ENGINEERING CHANGE NOTICE NO. 04048

DWG TITLE: STRUT

Engineering Change Request (ECR)

Subject Drawing/Document: 647.4300's

SIZE CAGE CODE DWG. NO. 647.4300 REV. A

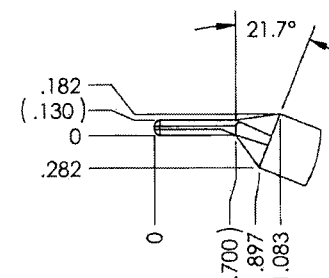
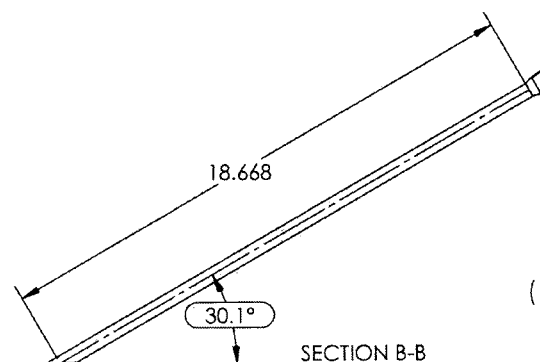
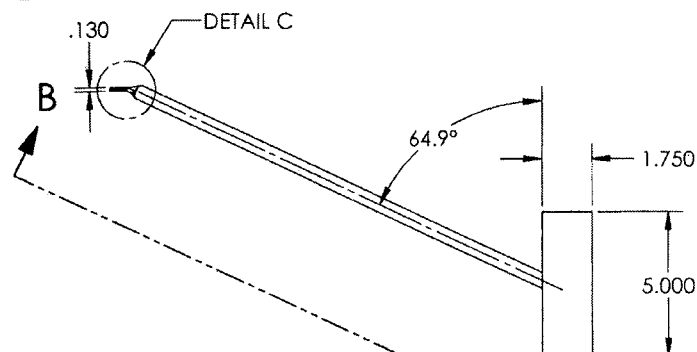
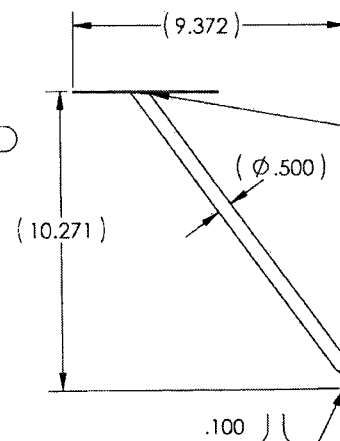
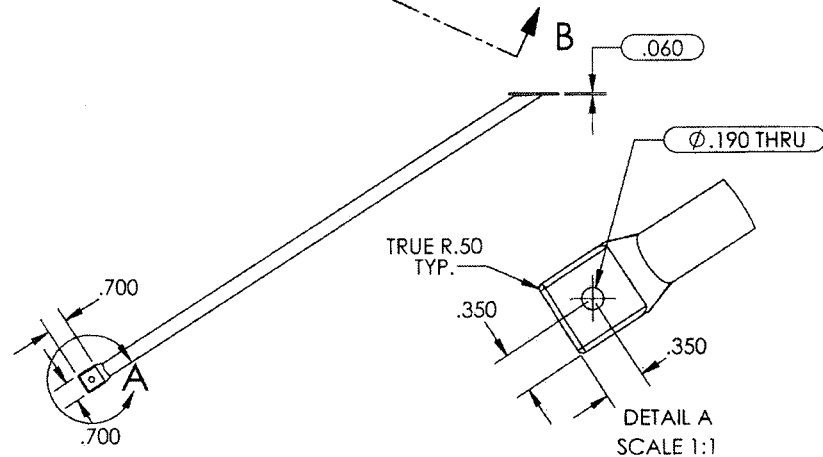
We are running into some cracking issues when fabricating these struts, Pablo recommendation was to go to SS material as discussed.

| Root Cause | | Date | Step | Qty | Description of work order update or non-conformance | Initial Chief Eng | Action Description | Sign & Date | Verification | QC Inspector |
|---------------|--|------|------|-----|---|-------------------|--------------------|-------------|--------------|--------------|
| Design | | | | | material change see attachment | | scrap & destroy. | | | |

| <small> ORIGINAL DATE (DATE) (TIME) DRAWN BY P. POLARIS CHECKED D. BARKER DESIGNED BY P. BRAVO APPROVED BY (DATE) (TIME) </small> | | APICAL INDUSTRIES 2608 TEMPLE HEIGHTS DR. OCEANSIDE, CA. 92036-3512 (760) 724-5300 | |

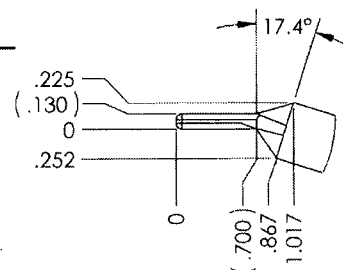
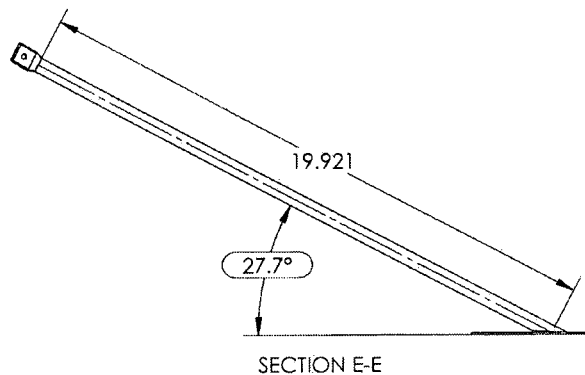
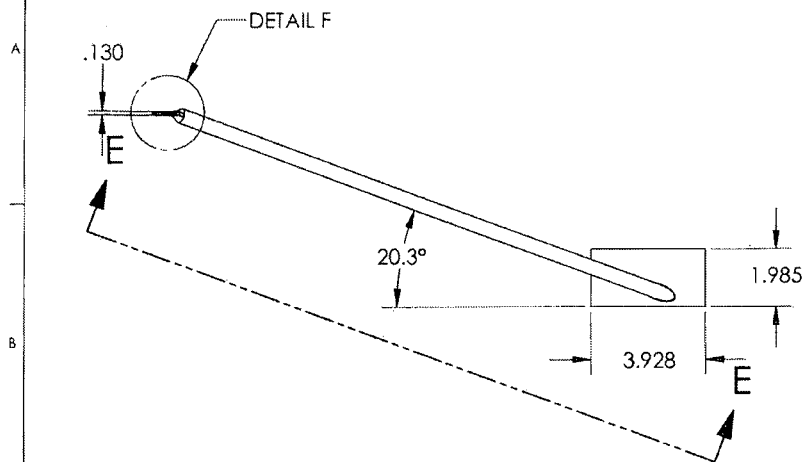
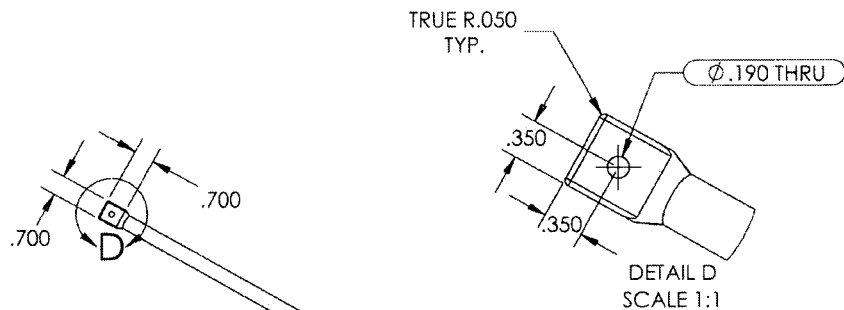
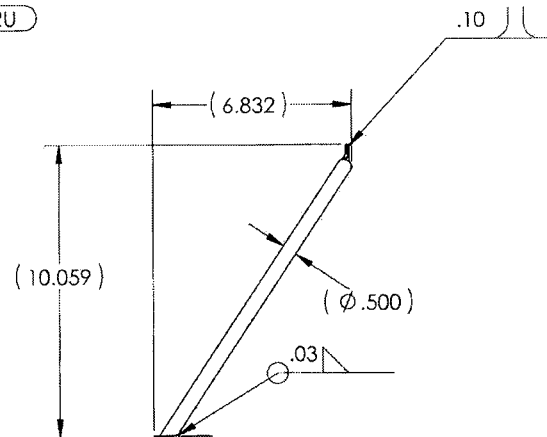
REASON: MARKED INSPECTION DIMENSIONS
